ENCLOSURE

INTERIM SAFETY EVALUATION REPORT  
ON EFFECTS OF FUEL ROD BOWING  
ON THERMAL MARGIN CALCULATIONS  
FOR LIGHT WATER REACTORS

FIGURE 2.1

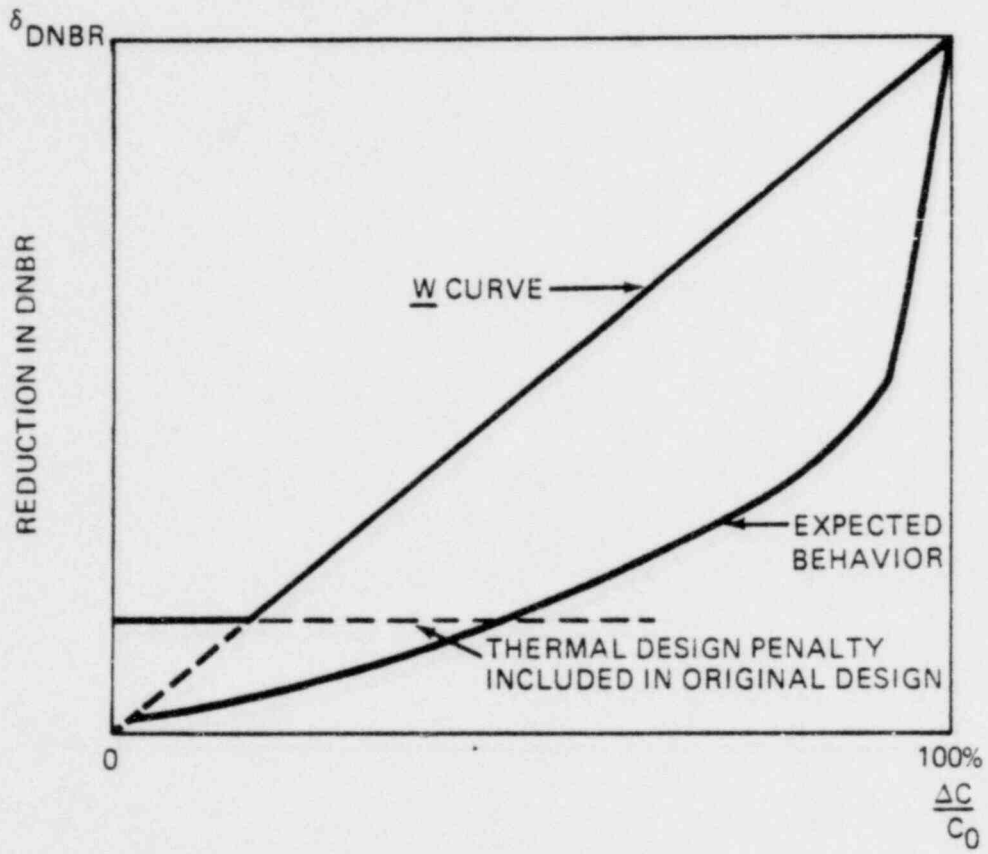
Data were presented by Westinghouse for the DNBR reduction at full contact and with no bow. No data at partial gap closure were presented. Westinghouse proposed, and the staff accepted, a straight line interpolation between these two points as shown in Figure 2.1.

This approach is conservative since one would expect the actual behavior to more nearly follow a curved line as shown in the same figure. The DNBR reduction would increase slowly in magnitude as the fuel rods bowed to contact. As the rods become close enough so that there would be an interaction between the two rods, the DNBR reduction would then increase more rapidly. No physical mechanism has been postulated which would lead to sudden large decreases in the DNBR for small or moderate gap closures. Thus, the straight line approximation is believed to be an overestimate of the expected behavior.

In developing the interim rod bow penalties described in this report, it became apparent that the penalty should be a function of burnup since the magnitude of rod bow is a function of burnup. However, to maintain existing thermal margins early in core life when only a small amount of fuel rod bow is anticipated, the initial pitch reduction factor was included until such time as the rod bow DNBR reduction became greater. This is represented as the straight horizontal line on Figure 2.1.
